Gorgon Gas Development

Response to Submissions: Gorgon Gas Development Revised and Expanded Proposal, Public Environmental Review

| Document No: | G1-NT-REPX0001731 | Revision: | 1 |

Figure 2.1: Location of the Approved and Revised Domestic Gas Pipeline (as presented in the PER) and Currently Proposed Pipeline Route

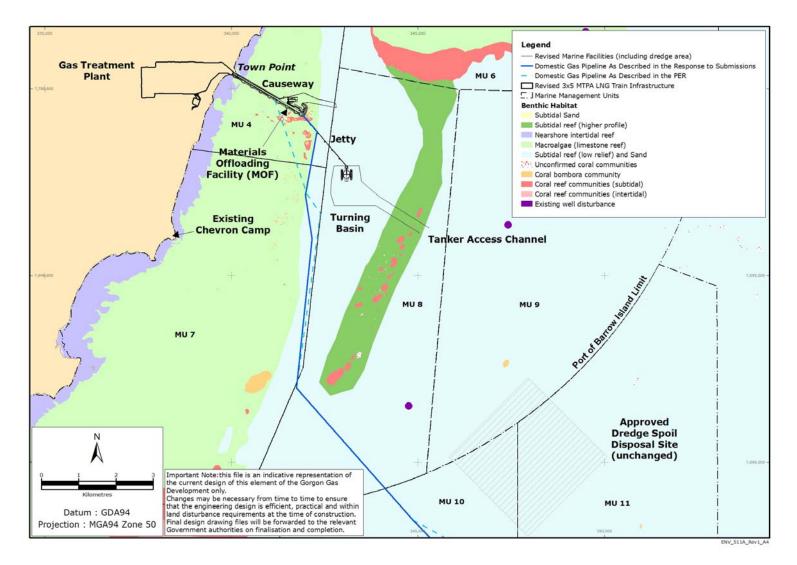
The Domestic Gas Pipeline design has been further modified since the release of the PER, owing to changes in engineering design with the aim of reducing the impact of the development on the marine environment. The off-take point has been moved from near the MOF on the causeway to a location on the jetty that is approximately 1.4 km further offshore. There has also been a minor repositioning of the pipeline to avoid sensitive benthic primary producer habitat within the Barrow Island Port (see Figure 2.1 in this document).

The total area of coral habitat that will be lost as a result of the Domestic Gas Pipeline realignment will remain unchanged. However, the realignment allows highly valued high relief subtidal and bombora coral communities that were previously affected as part of the Revised Proposal to be avoided (see Figure 2.1 in this document).

Realignment of the Domestic Gas Pipeline will alter the location of the marine disturbance footprint to the subtidal and intertidal seabed. However, the total area of potential impact of the Domestic Gas Pipeline will remain the same as that assessed as part of the Approved Development and the Revised Proposal (approximately 22 ha). The realignment will change the seabed profile in some areas; however, this is not expected to adversely affect the ecological integrity of the surrounding physical habitats. Rather, the realignment allows highly valued high relief subtidal and bombora coral communities that would have been affected as part of the Revised Proposal to be avoided.

There will be no change to the total area of marine habitat disturbance associated with the pipeline realignment. However, there will be a reduced impact on coral habitat. Realignment of the Domestic Gas Pipeline will move the pipeline away from coral habitats within Management Units 4 and 7 at the Barrow Island end of the pipeline, into areas dominated by low relief reef and sand. The previous pipeline alignment passed through predominantly macroalgae communities on limestone reef, with scattered coral habitat. The new alignment passes through areas of low relief subtidal reef and sand (Table 2.3 of this document). This results in the overall percentage of permanent coral habitat loss from east coast activities including dredging, the WA Oil Pipeline and the Domestic Gas Pipeline is reduced from 3.21% to 3.18% for the Revised Proposal (Table 2.3 of this document).
